**STAFF REPORT  
KETCHUM PLANNING AND ZONING COMMISSION  
MEETING OF FEBRUARY 9, 2021**

**PROJECT:** Westcliff Townhomes Pre-Application Design Review

**FILE NUMBER:** P21-007

**Exhibit B:**  
**Planning Review #1 Comments**  
**and**  
**Applicant Response**

GRADING PLAN  
**L-2.0**

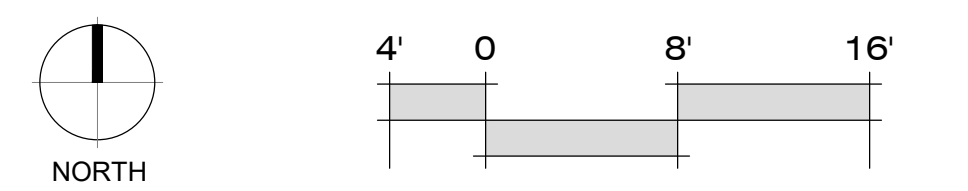
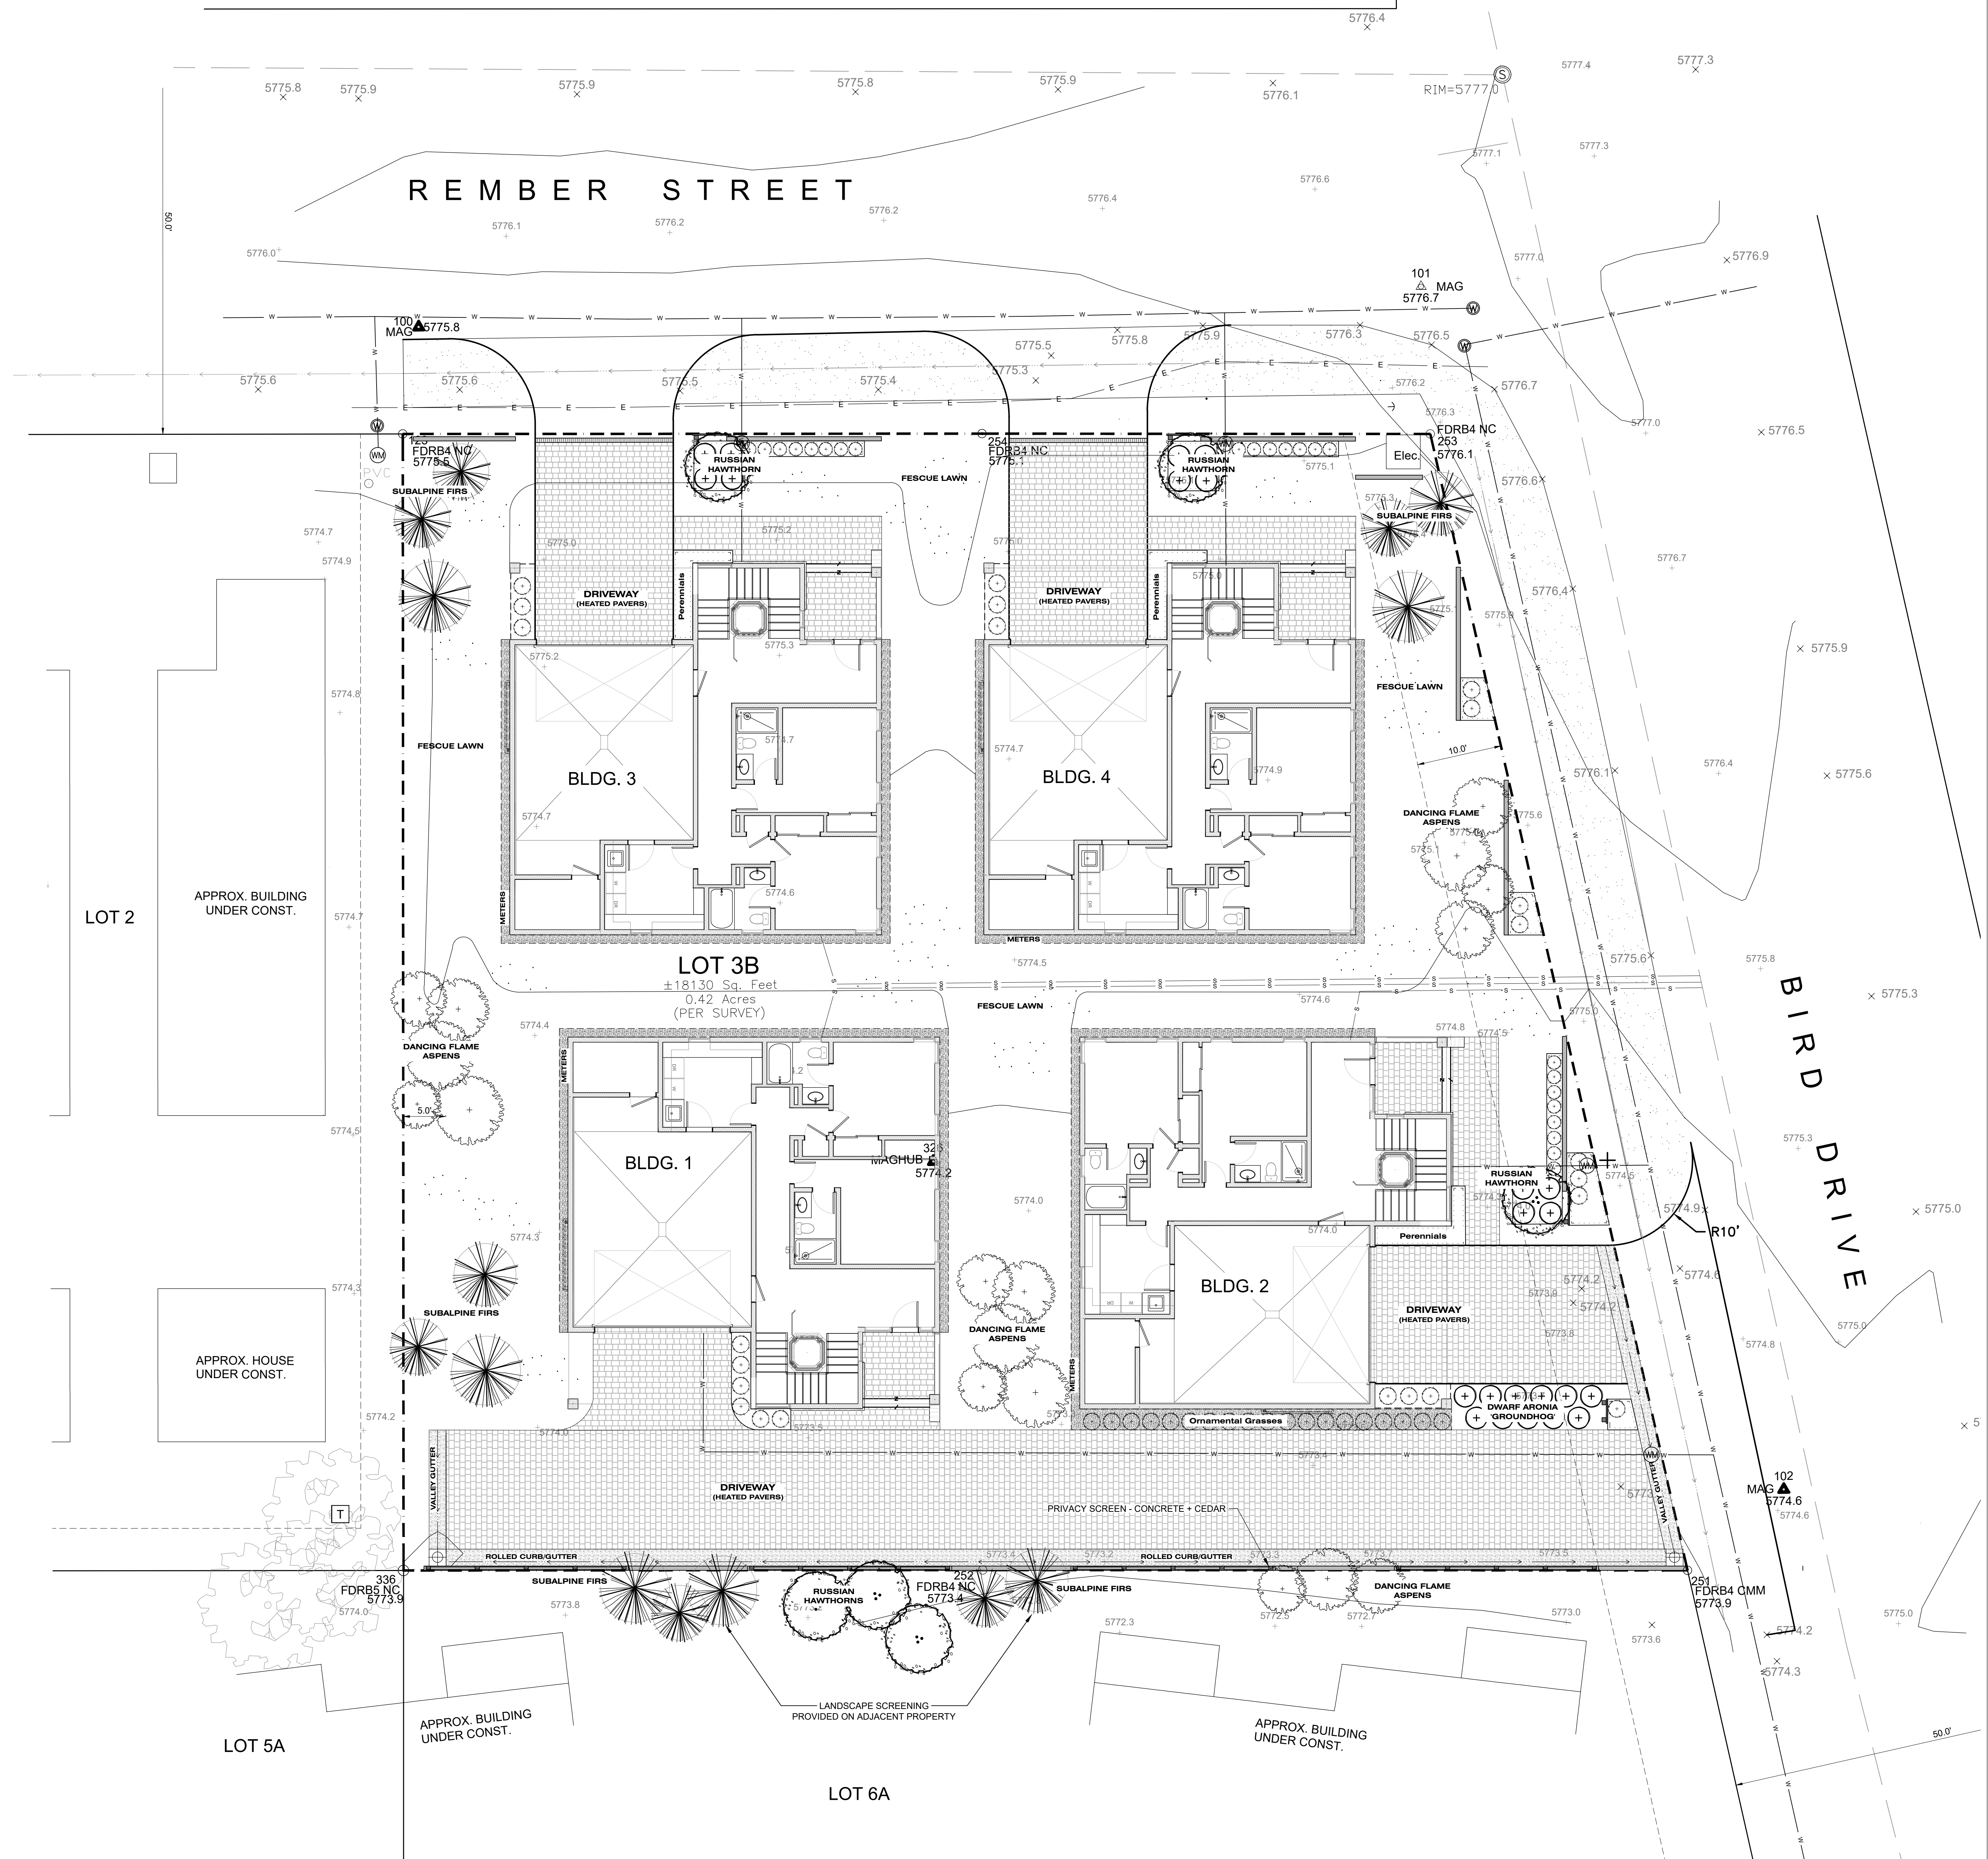
8	L-2.0 Grading Plan	The site wall elevation as shown on Sheet L-2.0 indicates that the address panels will be 5 feet tall. Ketchum Municipal Code §17.124.130 specifies that fences, hedges, and walls shall not exceed 4 feet in height when located less than 30 feet from the	<i>The proposed Address Panels are only 4'-6" wide, which we feel would not usually be considered to be a fence, hedge or wall.</i>

front lot line and shall not exceed 6 feet in height when located more than 30 feet from the front lot line.	<i>Given that Fire Code (bottom of numbers have to be min. 48" above finish grade), address markers have to be taller than 4'. Please advise. We welcome additional discussions.</i>
9	A3 Floor Plans	Indicate the parking stall dimensions within the 2-car garage on the first-level floor plan. Parking spaces must meet the minimum dimensions specified in Ketchum Municipal Code §17.125.030.	<i>Parking Stall Dimensions have been added to the floor plans on sheet A3</i>
10	A4 Roof Plan	The roof plan should specify proposed drainage for the gravel-ballasted membrane roof system. Pursuant to KMC §17.96.060.C1, all storm-water drainage shall be retained on site, including water from any roof drains.	<i>Roof drains have been noted on the roof plan, sheet A4, and will be internal drains hard piped to drywells noted on the Civil and Landscape Plans</i>
